Service Bulletin SB-0025

Subject: Wire Routing Improvements

Effectivity: K003 – K021

Affected Model(s): E1000, E1000 GX

v. Firewall Forward – MCU

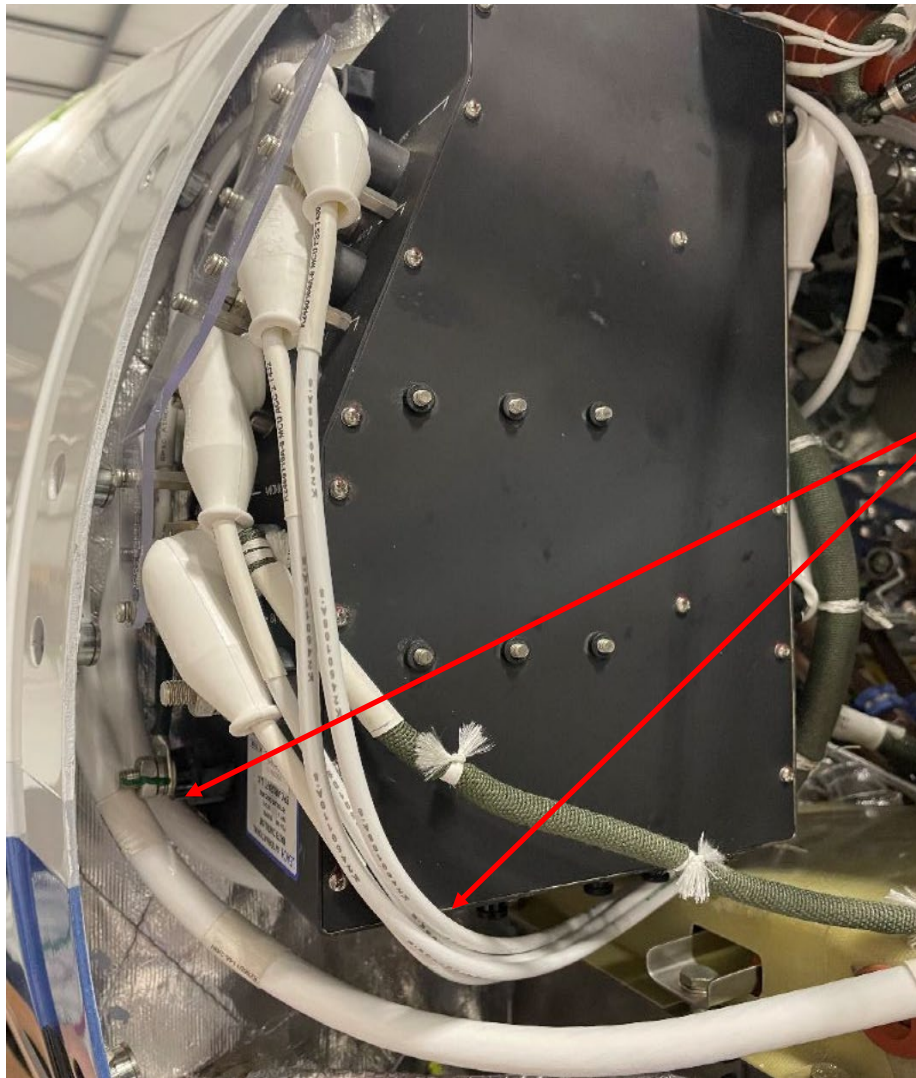
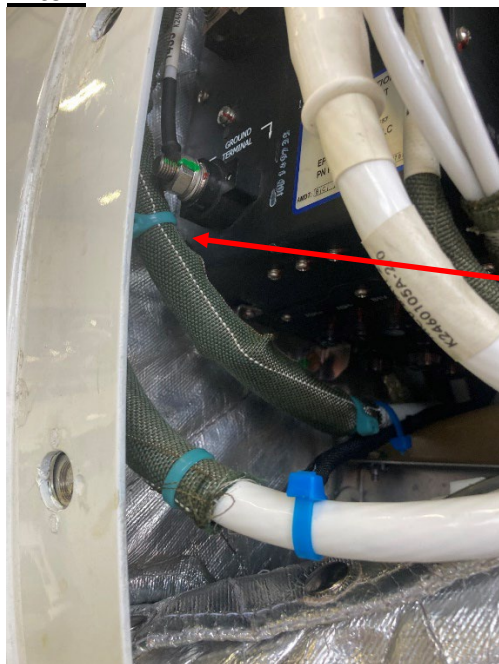
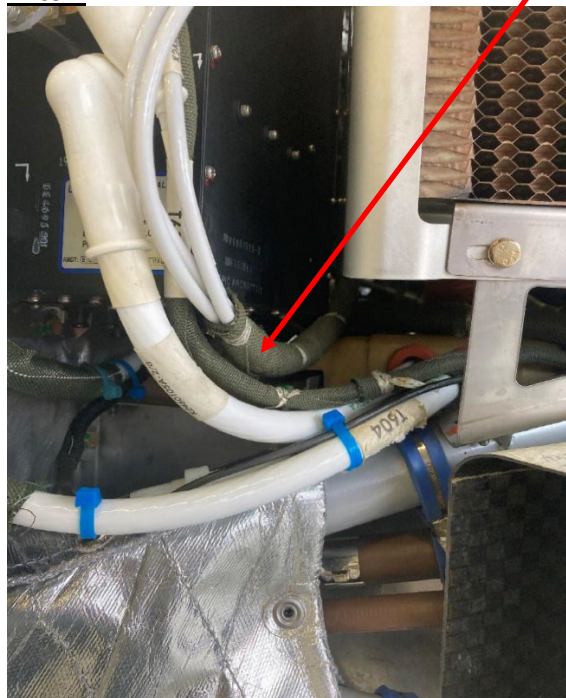
Action: Install Roundit on power wires to prevent damage from MCU case and ground stud.

Chafe hazard.

Install Roundit

w. Cockpit – Center Pedestal

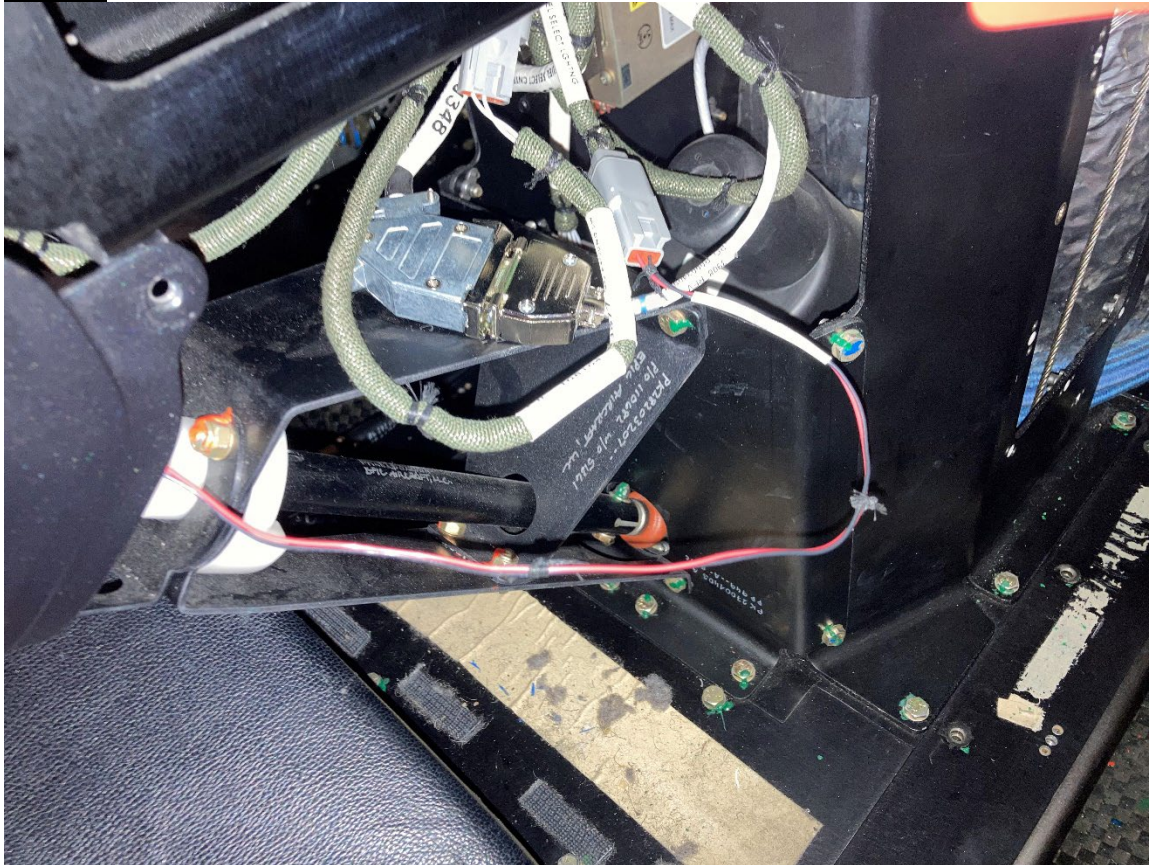
Action: Use tie wraps and tie mounts to secure the wire harnesses and connectors in the pedestal away from the fuel selector mechanism.
